**ARBORICULTURAL
IMPACT
ASSESSMENT**

(ADDENDUM)

Jacks Field,
Takeley

February 2023

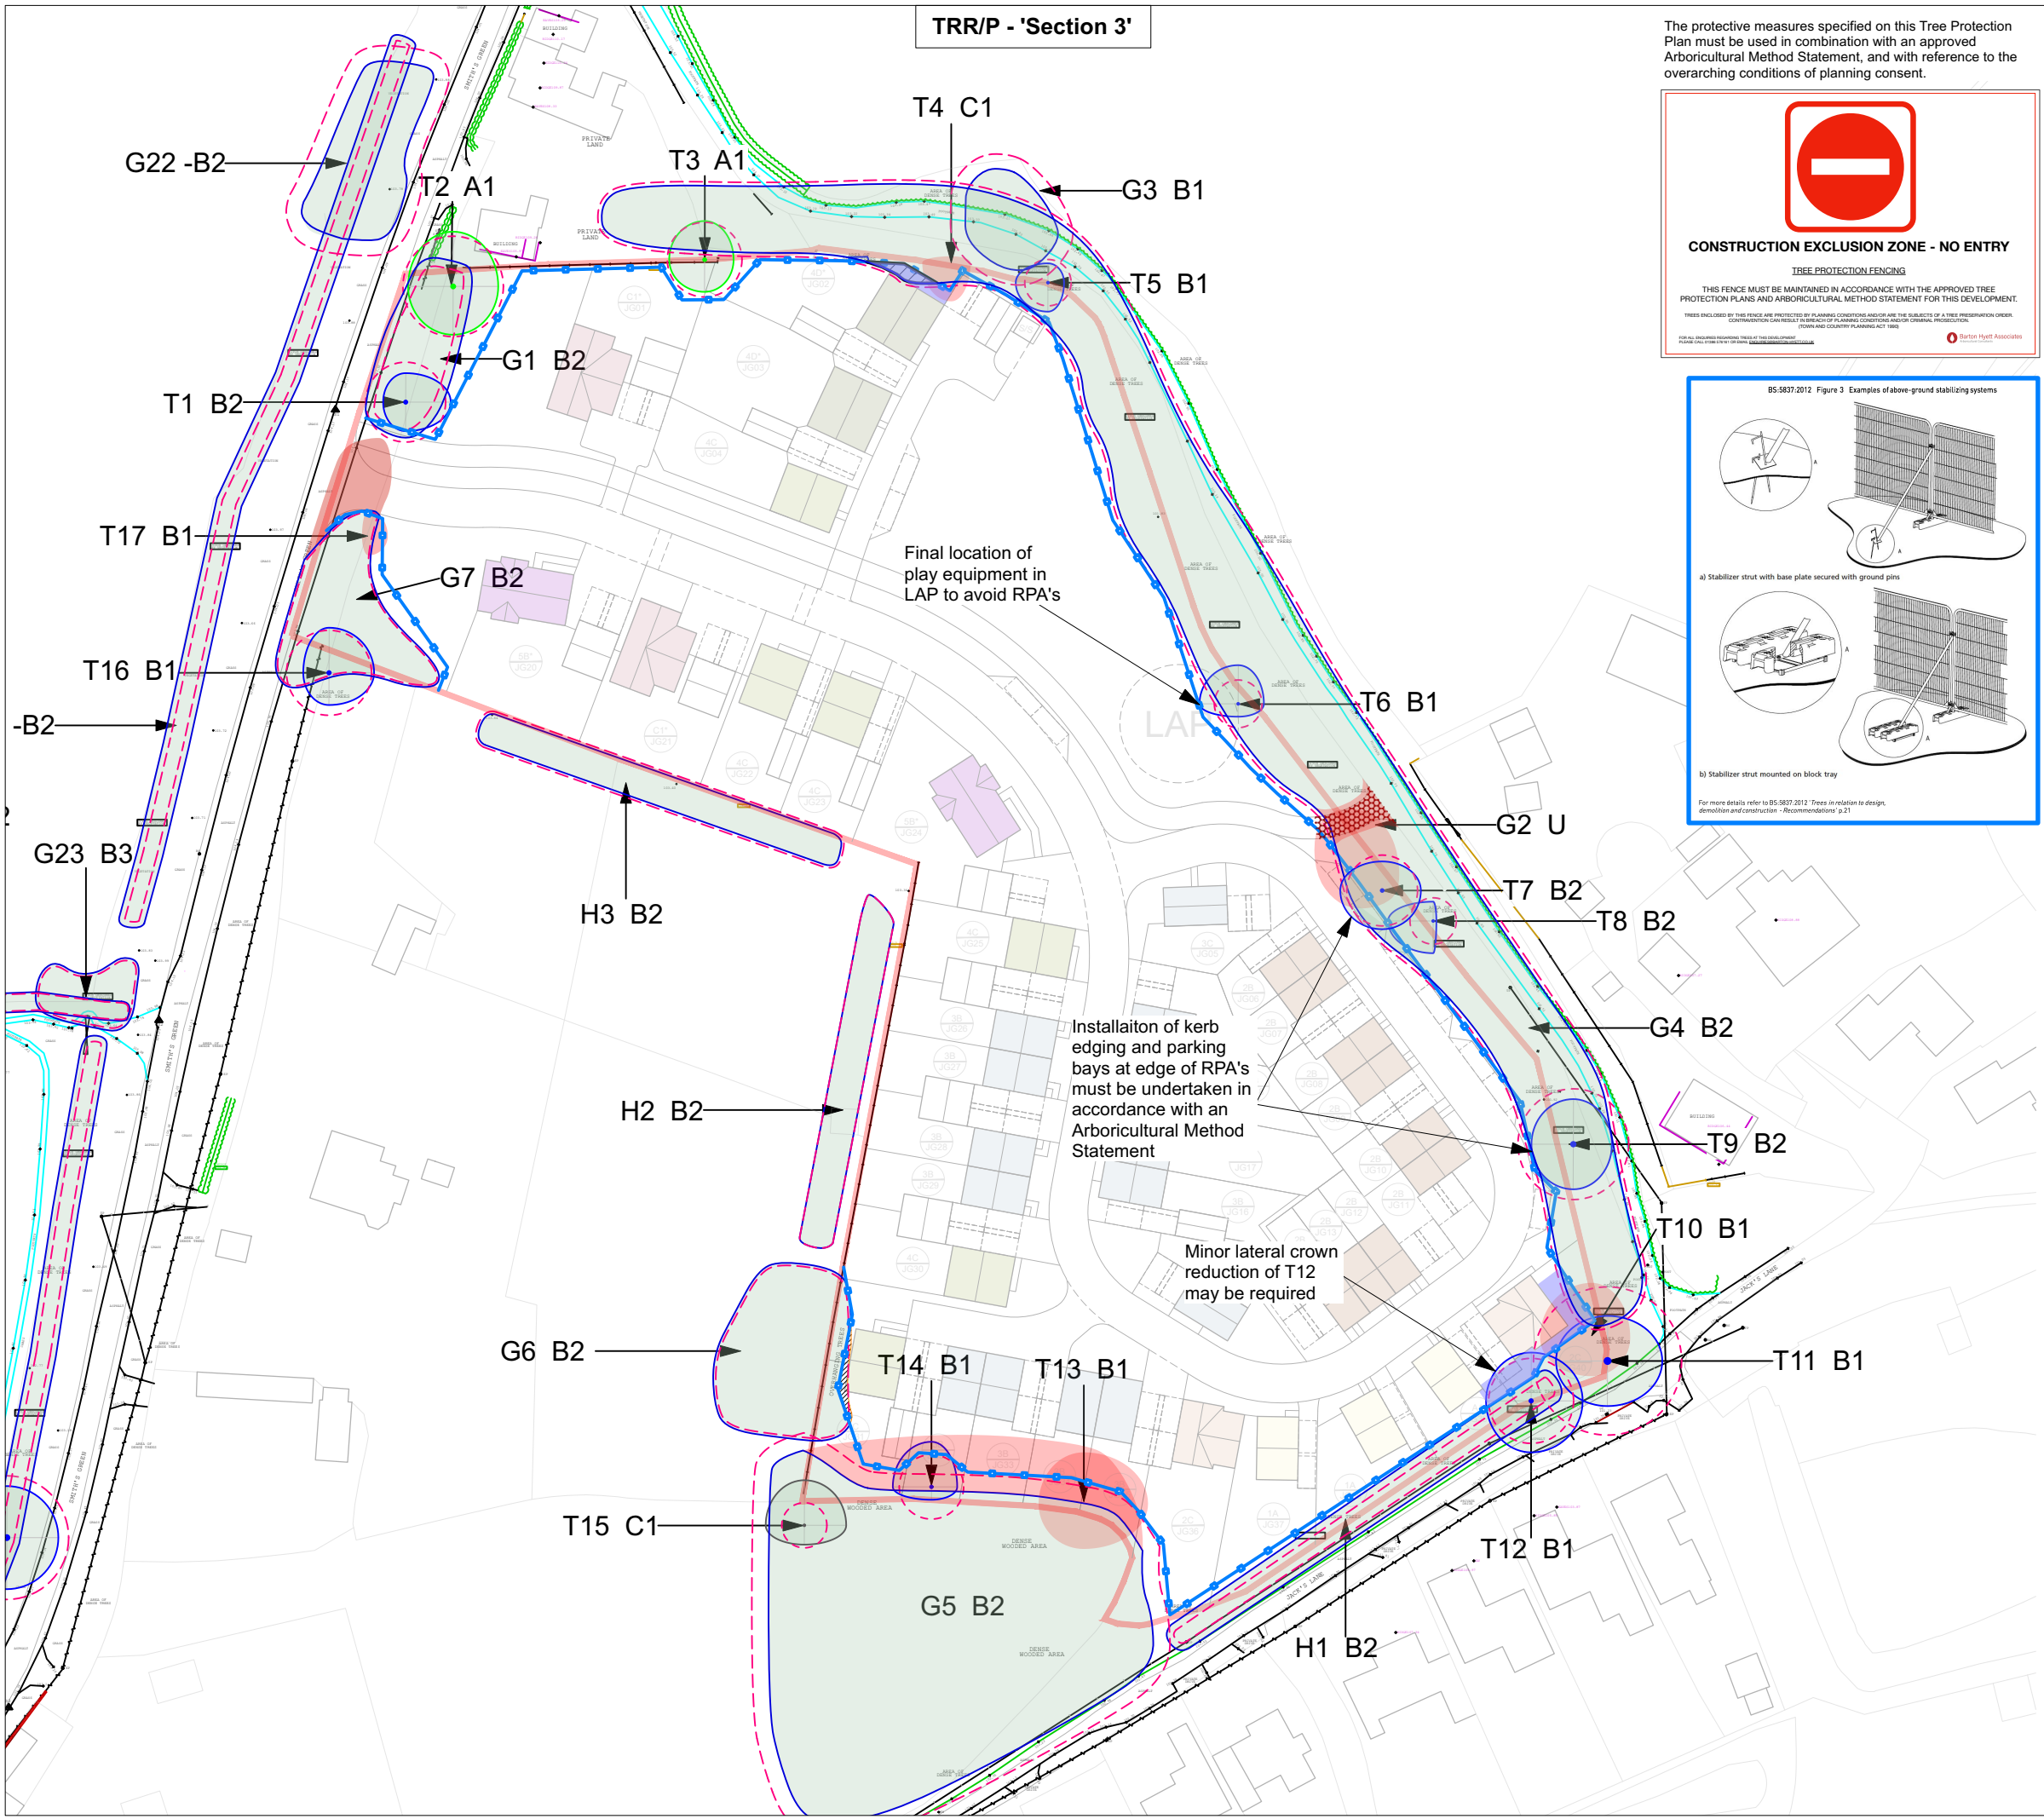
- 3.6. **Updated as footway/cyclelink has changed location and T7 (B2 - goat willow) can now be retained.** *Footway/cycleway link* - to create the access link through the eastern boundary of the site it will be necessary to remove some of the trees within G4 where they fall with the footprint of, or immediately adjacent to, the link. The removal of G2 (U) wych elm, is also proposed but this is on the basis of its very poor condition as category U trees should not be considered a constraint to development.

- 3.9. **Updated to reflect new plot positions.** *Facilitation pruning* - no significant facilitation pruning is required to allow the proposed development to be implemented. However, the minor lateral reduction of branches extending to the east of G6 (adjacent plot 31) and a very localised area of G4 (adjacent plot 2) will need to be undertaken in order to provide appropriate clearance to the proposed dwellings. The extent of pruning will need to be confirmed at the setting out stage. Trees T11 and T12 already has an average crown height of 6m and 5m above ground level, but some minor pruning (in the form of crown lifting and lateral crown reduction on their northern sides) will be undertaken if necessary.

- 3.12. **Updated as no longer a plot near the RPA of G5 but a plot is now at the edge the RPA of G4.** *Foundations* - New foundations are proposed within the RPAs of retained trees. There is a minor incursion into the RPA of G6 (plot 31), however, given the offsite location of the adjacent trees, the species, and the minor nature of the RPA incursion, no alternative foundation design is proposed. It will be necessary to carry out the foundation excavation under a watching brief. The same is true for G4 (plot 2). The detailed approach to the watching brief will be set out in a detailed arboricultural method statement (AMS). Where foundations are proposed within the RPA of T11 (plot 38) it is not envisaged at this stage that any alternative foundation design will be utilised. It is likely that any roots encountered will be pruned back to the edge of the trench excavation. However, prior to the implementation of the works on site and as part of the AMS preparation a series of trial holes shall be excavated in this area and the findings used to inform the final approach to construction. If significant roots are encountered that cannot be successfully pruned, the approach may be to implement an alternative foundation design (eg. pile and beam).

- 3.13. **Updated to reflect adjusted locations of drives and parking bays near RPAs.** *Hard surfacing* - the vast majority of proposed hard surfacing is located outside of the RPAs of retained trees. However, the proposed footway/cycleway link to the east of the site will be located within the RPAs of trees within G4. In this location it is proposed that a 'no dig' approach to the construction be used. This may include the construction of the parking bays on the existing ground surface and may also utilise a 3d cellular confinement system to assist in distributing loads applied by vehicles and preventing compaction of underlying soil. However, the final surfacing design needs to be prepared by the project engineer and based on a detailed ground investigation to ascertain the current condition of the soils and whether their structure is such that they could be compacted to the point where root growth is negatively affected or inhibited. The final design will also need to take into account the previous agricultural management of the land and the presence of any drainage ditches within G4 which may have inhibited root growth in this area. The final surfacing design will need to be implemented in accordance with the working methodology set out in a detailed arboricultural method statement (AMS). In addition, the revised layout indicates that small areas of private parking bays (plot 2, plot 39 and plot 40) marginally encroach into the RPAs of adjacent trees. No alternative surfacing design will be utilised. It is anticipated that any roots encountered will be pruned back to the edge of the excavation required to achieve formation level for the parking bays. This will need to be addressed within an Arboricultural Method Statement.

- 3.15. **Updated as road alignment and public parking bays within RPA of G4, T7 and T9.** *Highway infrastructure* - no new significant highway infrastructure is proposed within the RPAs of retained trees. However, there is a minor encroachment of the road alignment into the RPA of T9. Given the level nature of the site and the likely formation depth required for the road, no alternative surfacing approach is proposed. The adjacent parking bays may be reduced dig in nature due to the potential shallower depth of construction. Again, no alternative surfacing approach is proposed. Installation of the kerb edging and parking bays at edge of RPAs must be undertaken in accordance with an Arboricultural Method Statement which will set out the approach to a watching brief on the excavations required at the back edge of the parking bays and detail the likely extent of any root pruning.
